## **AMENDMENTS TO THE DRAWINGS:**

## **REMARKS**

**Fig. 1**  
(PRIOR ART)

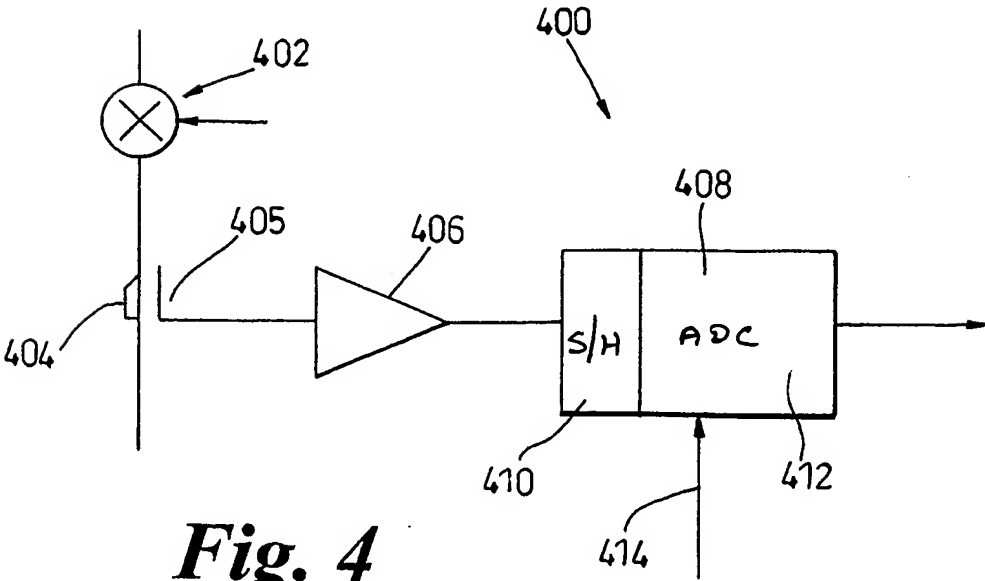
The examiner objected to the drawings for lacking descriptive text labels on Figures 1, 3-5A, 8 and 9.

Figures 1, 3-5A, 8 and 9 are amended to add appropriate textural references. The amended Figures include Figures 1, 3, 4, 5, 5a, 8 and 9. Marked up sheets of amended Figures are attached at Appendix A of this Reply. Four sheets of Replacement Figures are attached at Appendix B of this Reply.
